Noyac Bay

Suite 507.

SUITE 507
ORIGINAL LAYOUT
INVENTORY SUITE
(new)

ROOM: KITCHEN BULKHEAD PLAN

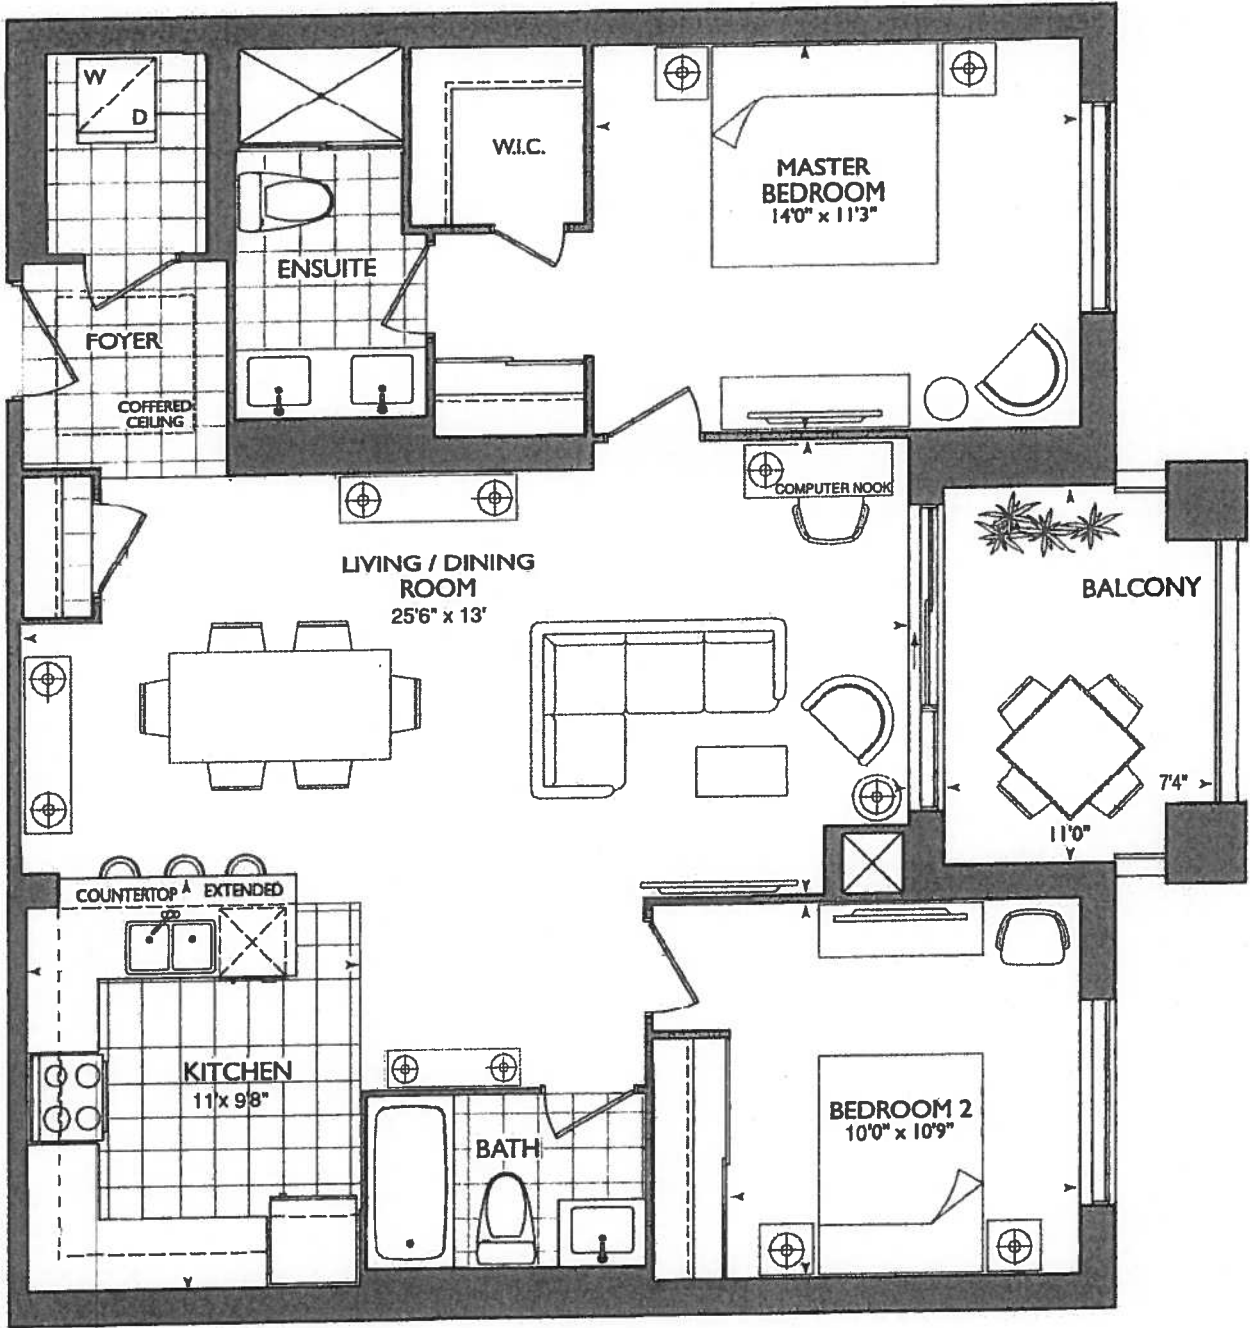
- NEW PLAN
- REMOVED DEN
- REVISED KITCHEN

***REVISED LAUNDRY DOOR SWING &
ENSUITE WALL AS PER THIS BROCHURE**

**#1- KITCHEN LAYOUT WITH 1ST UPG.
APPLIANCE PACKAGE**

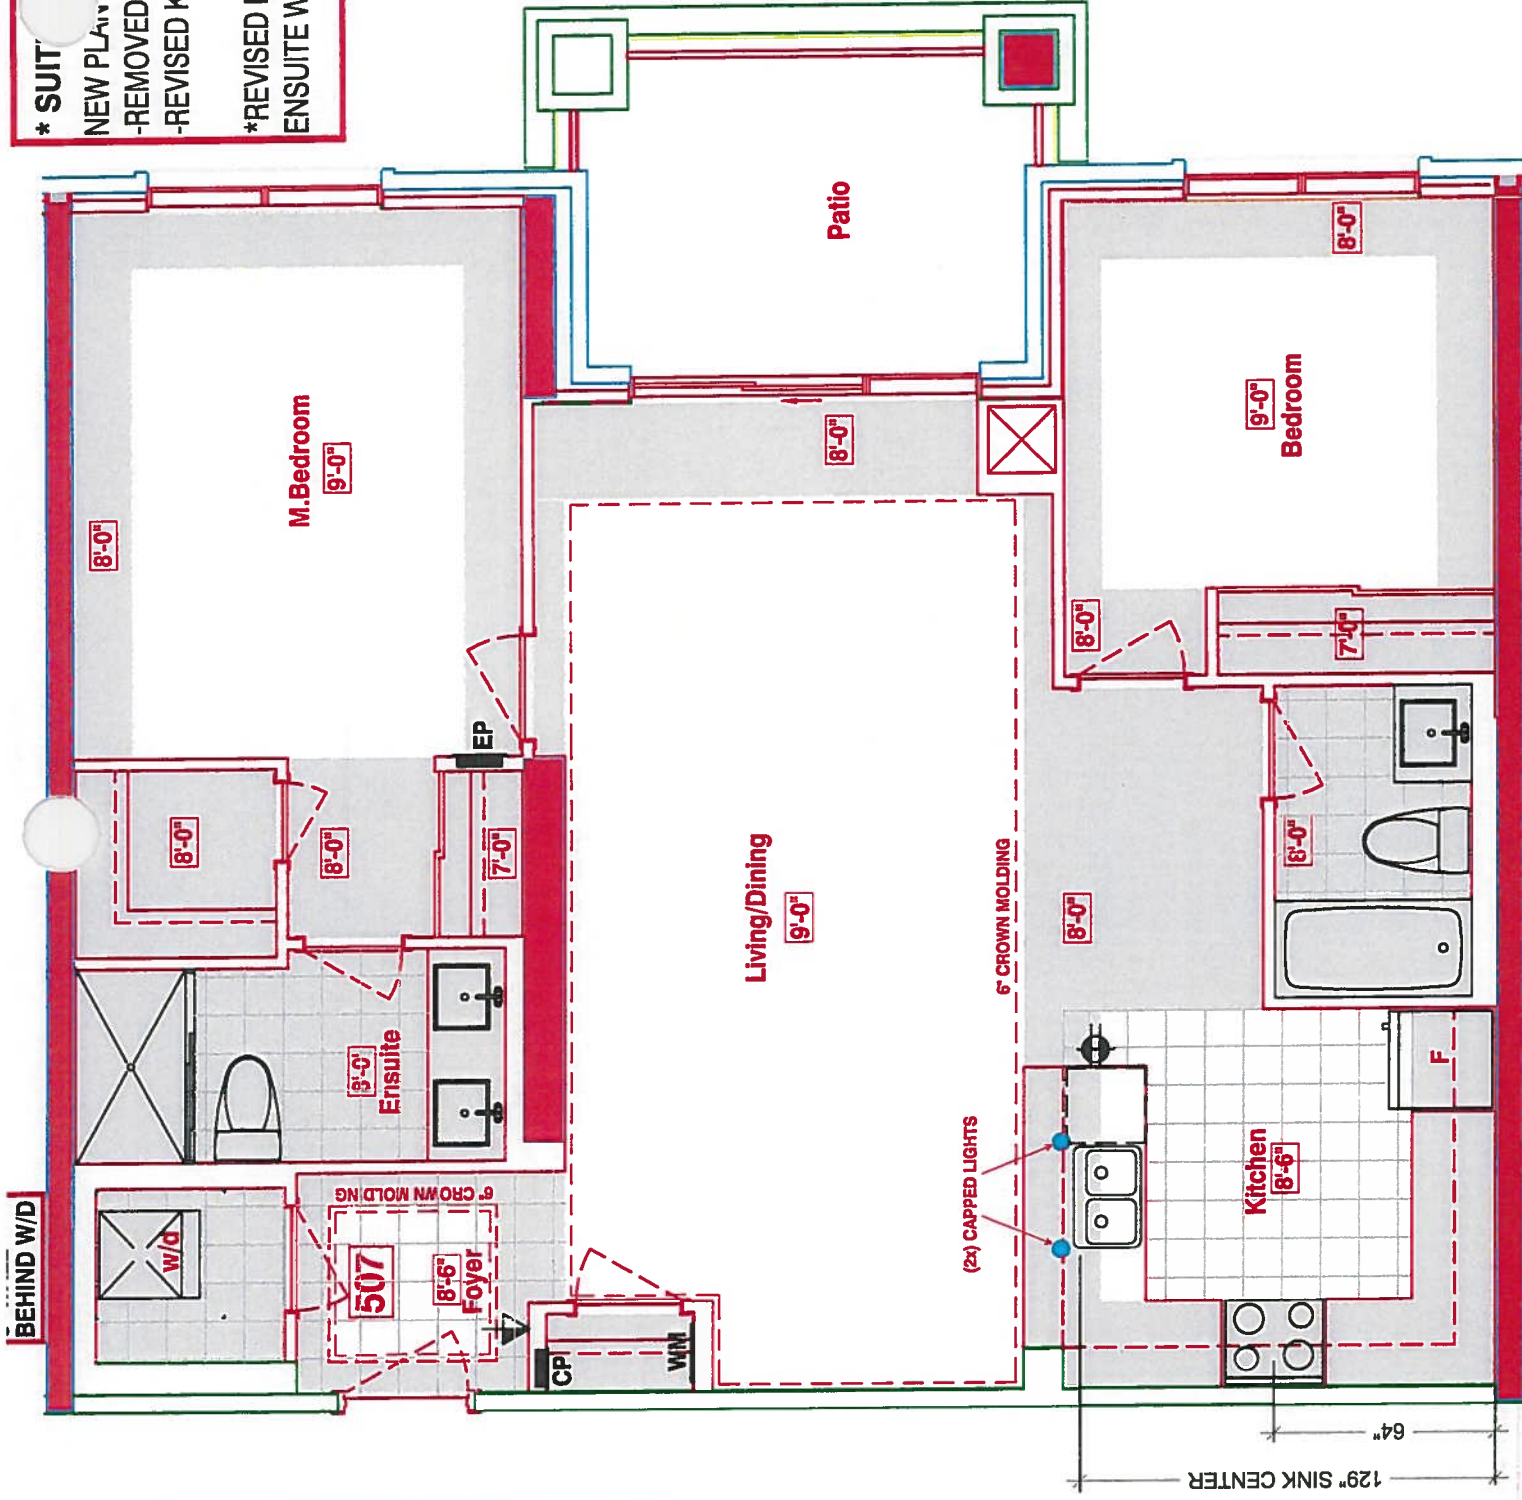
*** KITCHEN ***

CHOICE OF STD. KITCHEN LAYOUT WITH
STD. APPLIANCE PACKAGE

OR

CAN UPGRADE AT DECOR CENTER

- (x2) CAPPED PENDANT
- (x1) PLUG PENINSULA
- (x) PUCK LIGHTS

***SEE ATTACHED UPG.**
